American Telecommunications Certification Body Inc.  
6731 Whittier Ave, McLean, VA 22101

RE: Airo Wireless Media, Inc.

FCC ID: QDLA25TVVJ

After a review of the submitted information, I have a few comments on the above referenced Application. Depending on your responses, kindly understand there may be additional comments.

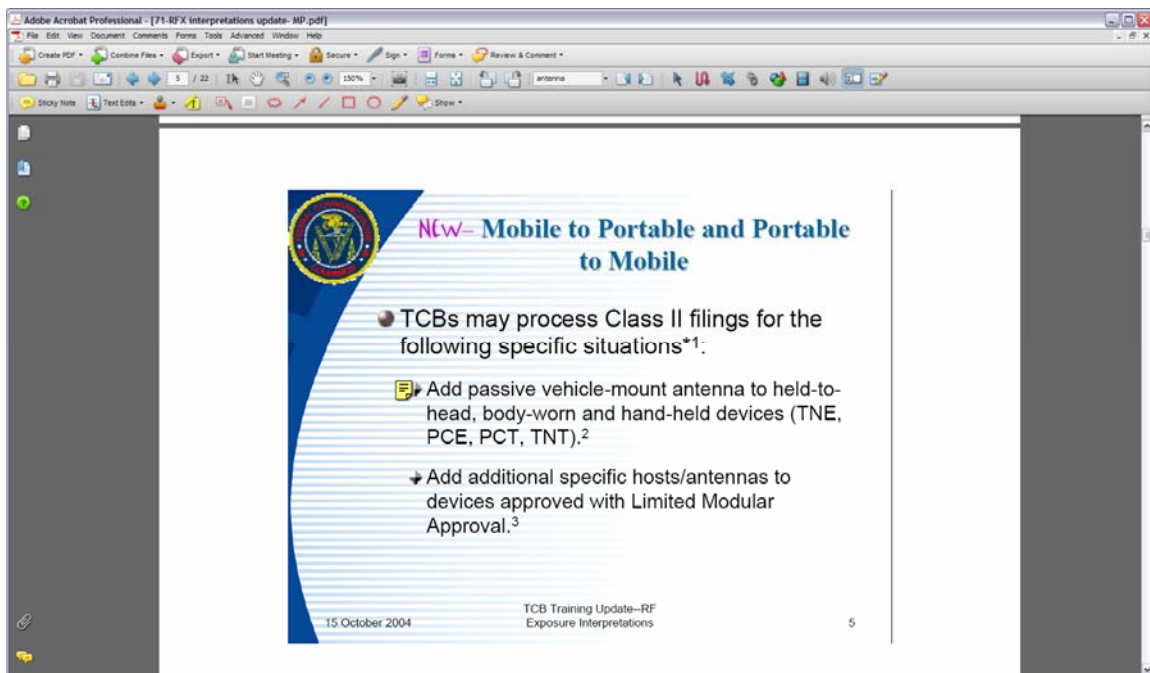
It seems some confusing information uploaded 9/3 that contradicts information provided on 8/24

- 1) Previous response to item 5 would be acceptable if this was only intended for the factory as you cite. However users manual pages page 1 (item 14) and page 10 clearly identifies this as an external antenna connector which appears to be intended for the user. The concern is that use of this antenna would require evaluation of appropriate ERP and EIRP power measurements, MPE, and even possible evaluation of spurious emissions as given in FCC training from October 2004. This comes from the fact that the power must be listed as ERP and EIRP. Therefore the external antenna will have an effect on this measurement. See below.

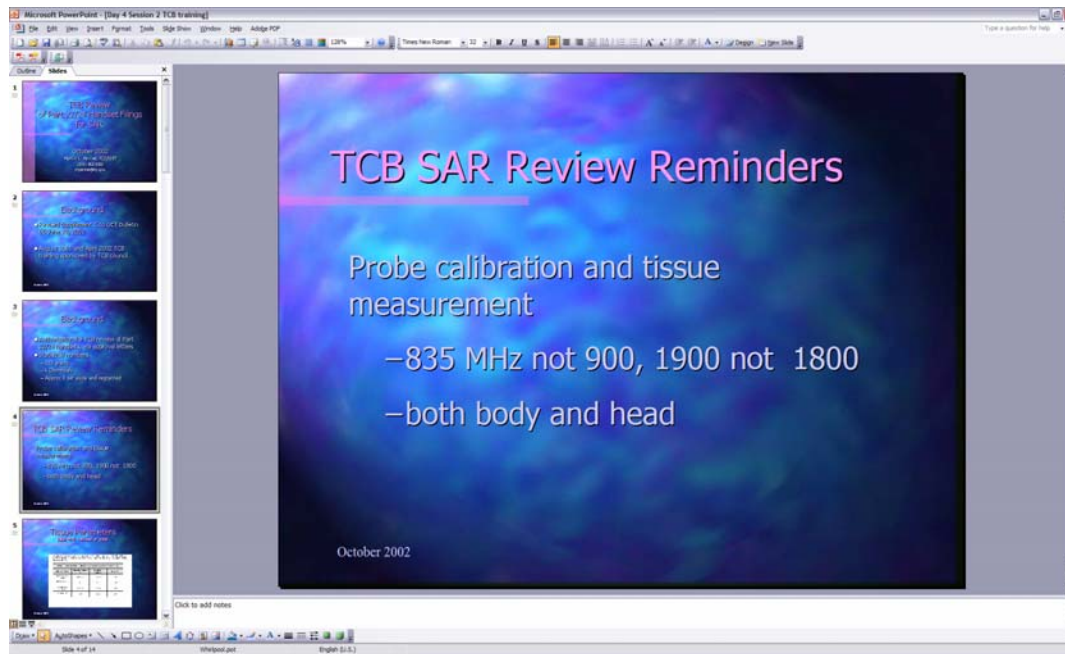
- 19) Tissue dielectric parameters and probe factors must be measured at mid band frequencies (i.e. 835 MHz). See below....It is also uncertain if the probe factors of +/- 50 MHz or +/- 100 MHz apply under the calibration certificate given the note given.
